### SAN FRANCISCO PLANNING DEPARTMENT

### Discretionary Review Abbreviated Analysis

Date:	May 5, 2011
Case No.:	2011.0194D
Project Address:	4090 26 <sup>th</sup> Street
Permit Application:	2010.10.05.2258
Zoning:	RH-2 [Residential House, Two-units per Lot]
	40-X Height and Bulk District
Block/Lot:	6553/020A
Project Sponsor:	James Barker
	John Lum Architecture Inc.
	3246 17 <sup>th</sup> Street
	San Francisco, CA 94110
Staff Contact:	Sharon Lai – (415) 575-9087
	sharon.w.lai@sfgov.org
Recommendation:	Do not take DR and approve as proposed

I SIDE (EAST) ELEVATION/SECTION - PROPOSED Scale: 1:48

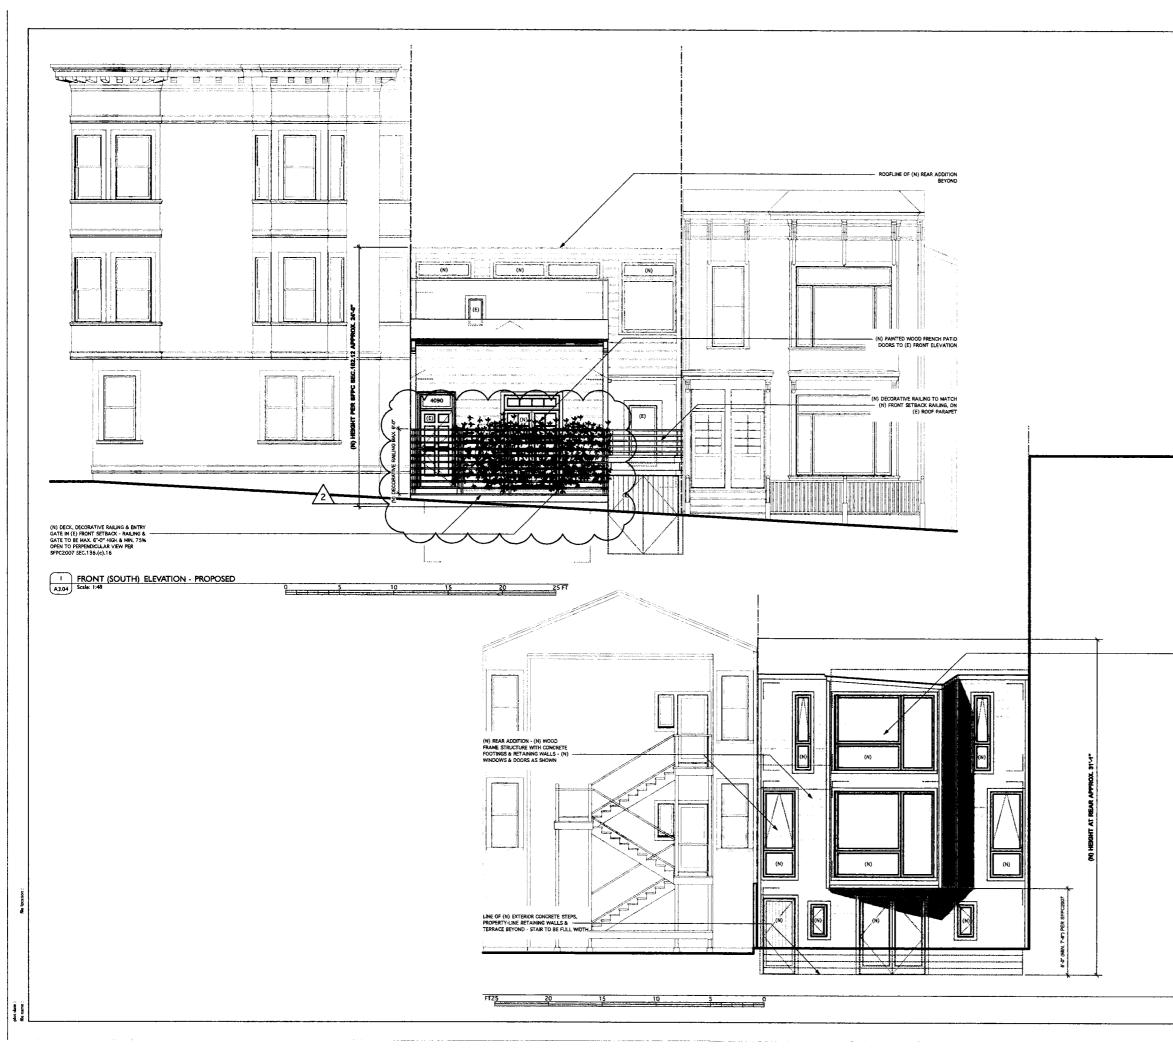
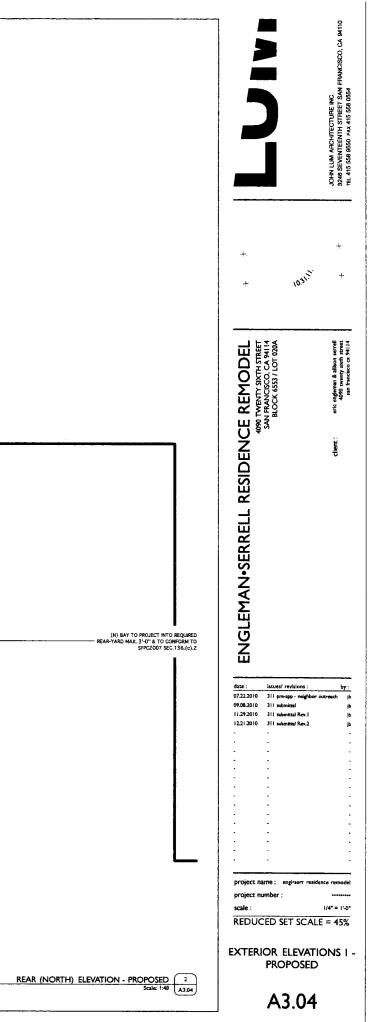
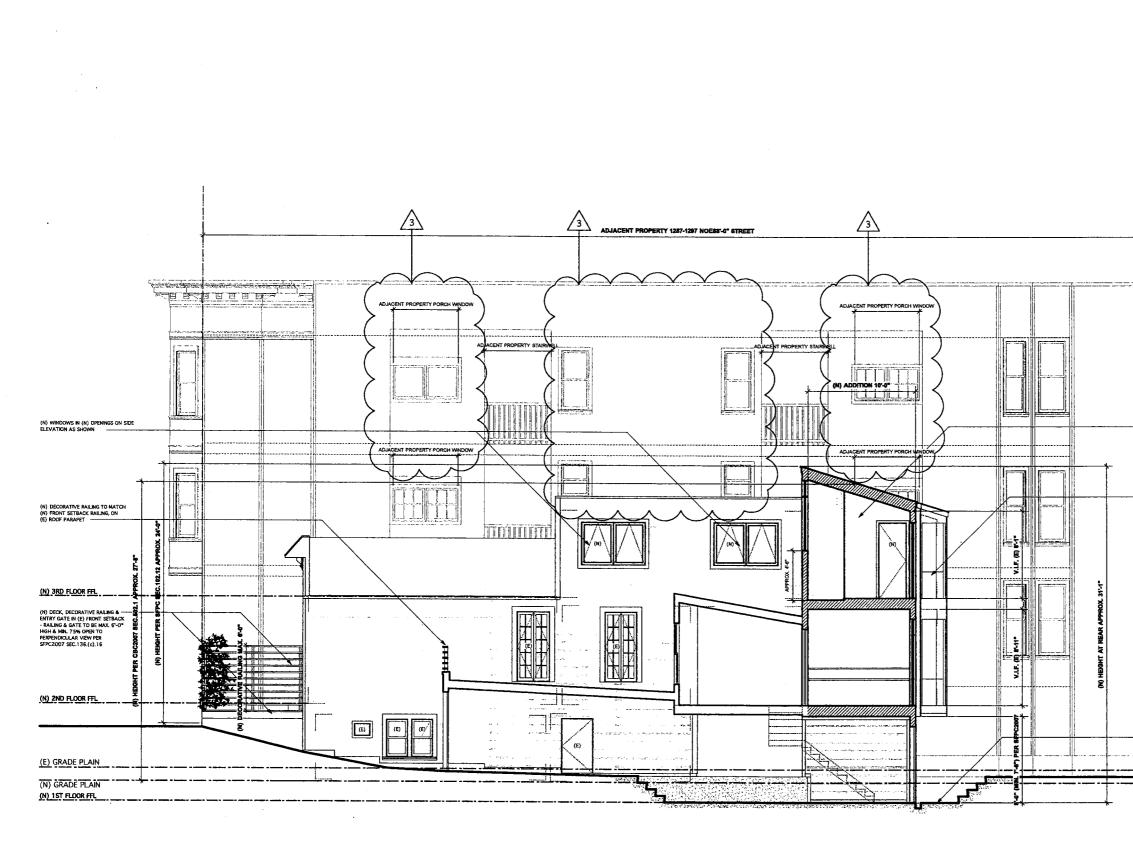
The City requires that all facing windows, including lot line windows, be shown on the plans. The back porch/stair landing windows have been omitted from all but the (unaffected) top floor of 1287-1297 Noe Street. This includes the stair landing from the top floor. Please submit revised plans that show ALL windows.

Elevations incorrectly label rear porches as "storage rooms." These are spaces used by tenants for various functions, including their OFFICES. They are <u>not</u> windowless storage rooms but part of their living spaces. Please correct.

In respect to your comment about deficiency in our plans, I would suggest that you go to the site to see how Ms. Medal's building has been altered. We don't think that the labeling of the rooms is inaccurate, as habitable rooms need natural light and air per the building code.

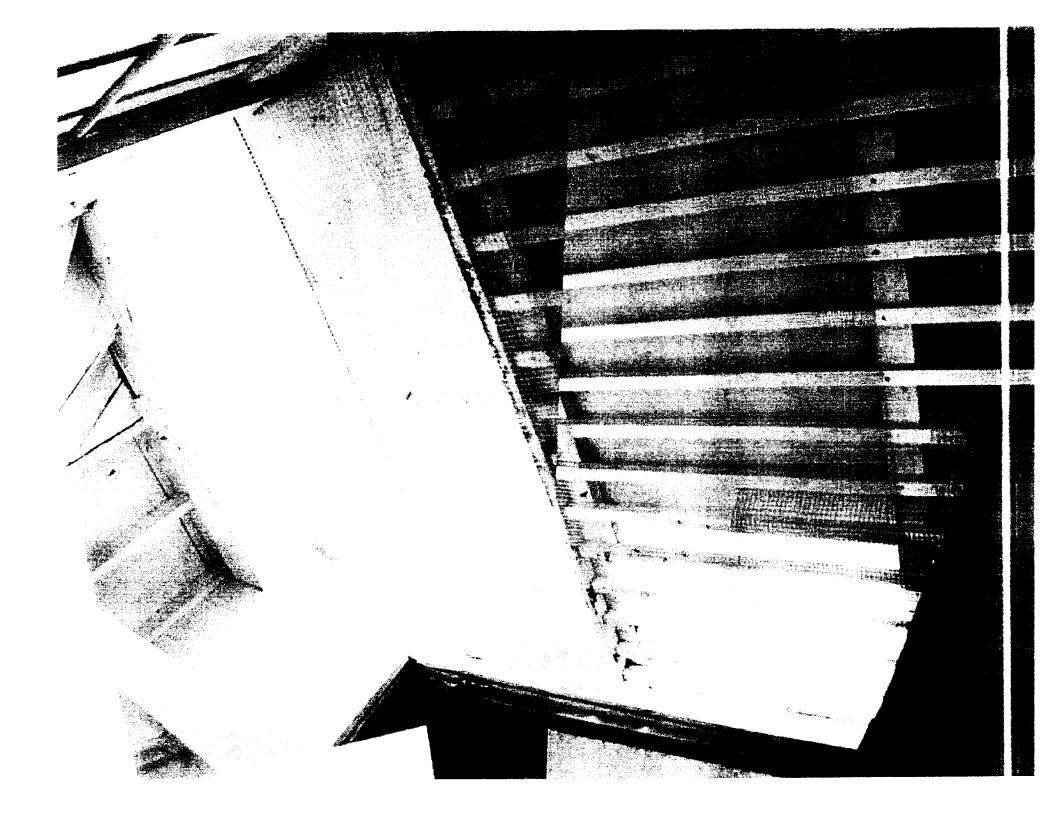
This is a request that a story pole or poles be constructed to show the slanted roof of the proposed extension of 4090 26<sup>th</sup> Street where it is adjacent to the exterior stairwell of Ms. Medal's building at 1287-1297 Noe Street. The Planning Commission encourages story poles to give an accurate portrayal of the impact of a proposed addition. In this case only one location is requested - the corner abutting the stairwell - and it should be easily attached to the existing addition.

A story pole that shows the outline and exact location of the slanted roof for the clerestory windows

would give accurate information on how much light will remain into the stairwell and rear of the Noe Street apartments. Ms. Medal is trying to preserve as much light into the apartments which already lost the window into their rear porches.

There is no planning requirement for story poles, and we believe that the installation would not yield any pertinent information, as story poles are typically used to visualize the height of a new addition. Since Ms. Medal's property looms 1 1/2 stories over the Engleman/Serrel's property, it appears this request is perfunctory.

We understand that the addition will affect some of the light that enters the stairwell. However, since the stairwell appears to service only rear porches, there is no code requirement for natural light to these areas. Additionally, openings along property lines are not protected from the planning code, as this would be a construed easement.

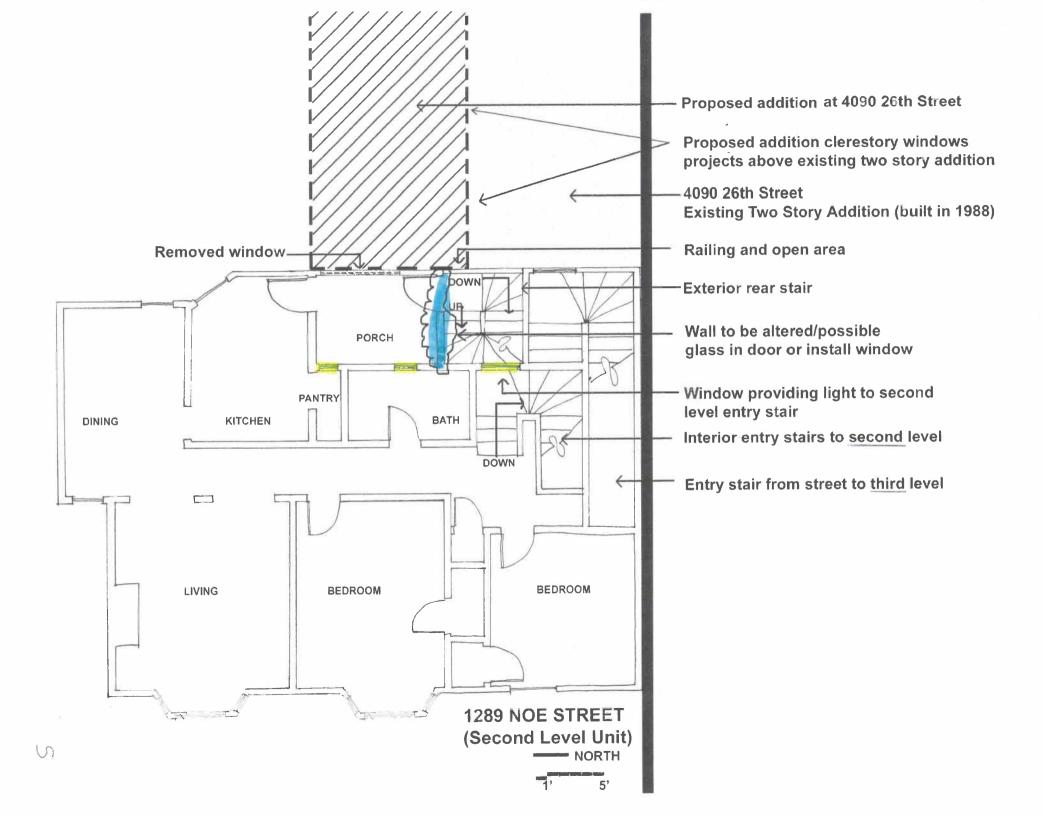
The following page shows the **layout of the 2<sup>nd</sup> floor 1289 flat if the proposed rear addition is built**. The cross-hatched area is the new addition which extends the width of the lot. The clerestory window rises 3' feet at the juncture of the existing and proposed rear additions. This is directly in front of the remaining opening in the open rear staircase - <u>and closes off light another 3 feet higher</u>.

This graphic illustrates shows how light has been lost through removing the rear porch window and blocking the entire width of the open staircase. The entire width of the open staircase is blocked by the horizontal expanse of the new 3-story addition.

But light into the stairway remains possible -- as well as light in the stairway flowing through the window at the west, into the interior of the 1289 flat. If windows are added in the north wall of the staircase, light could still come through the window into the bathroom. This can be accomplished by (a) installing a glass door or window between the rear porch and the rear staircase, and (b) not allowing additional height against the open staircase which would impede that light.

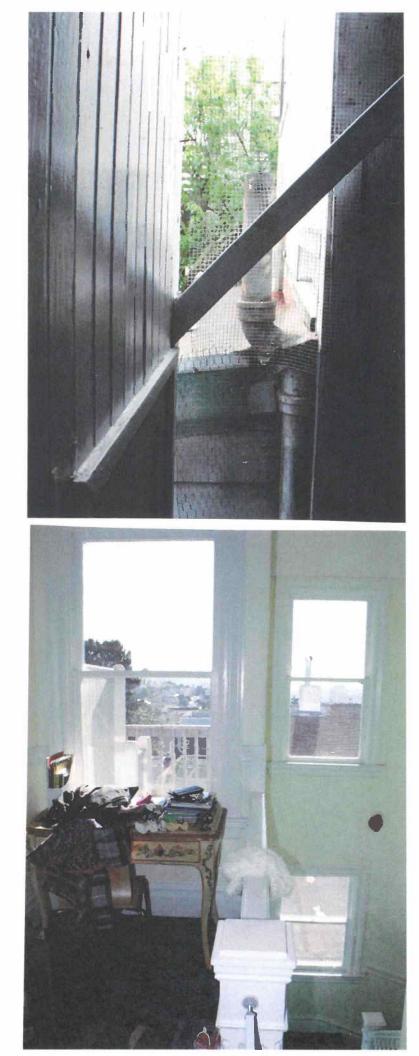
There appears to be a ventilation stack at this location. It is not clear from the plans whether it will still be needed and simply extended two stories higher outside the 3<sup>rd</sup> floor flat at 1291 Noe.

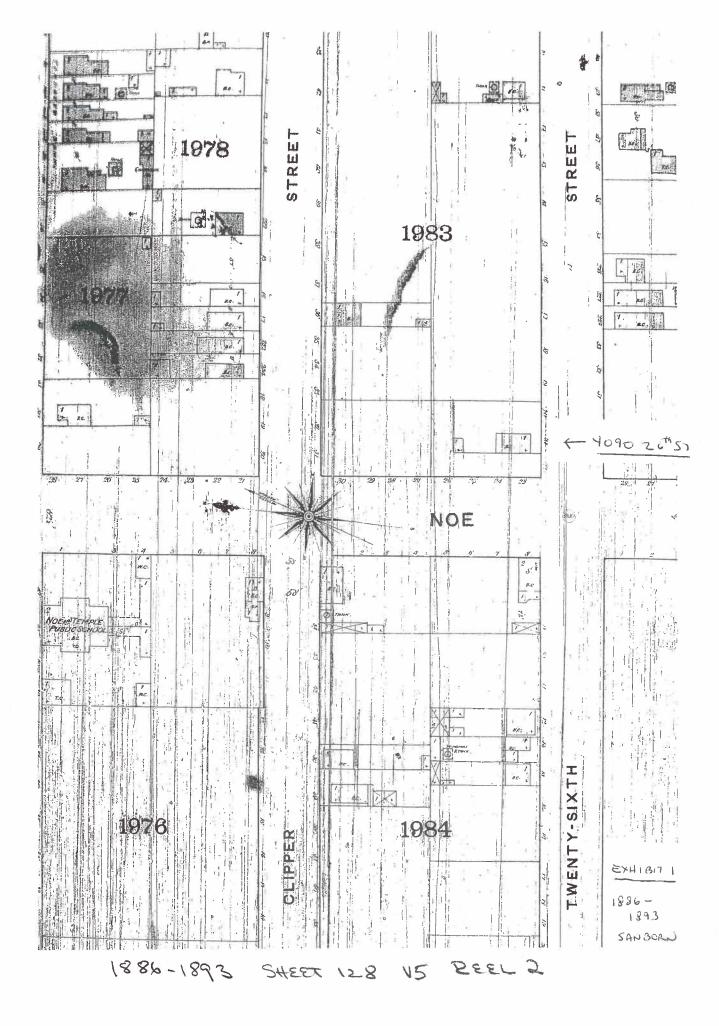
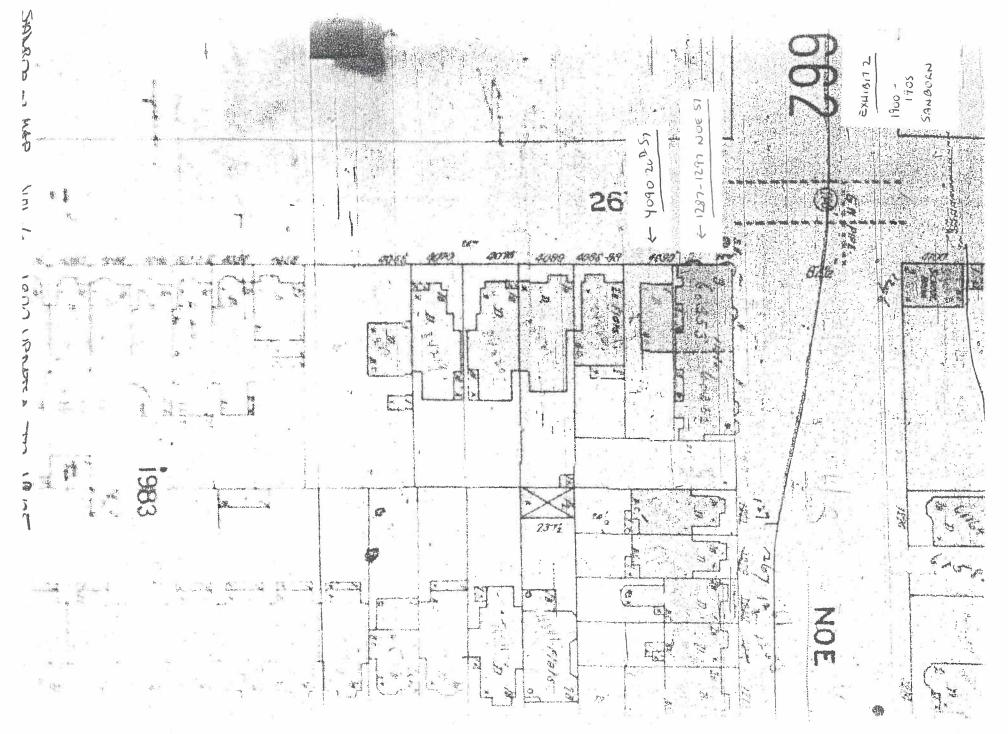
Removal of the clerestory window is required given all of the facts of this matter.
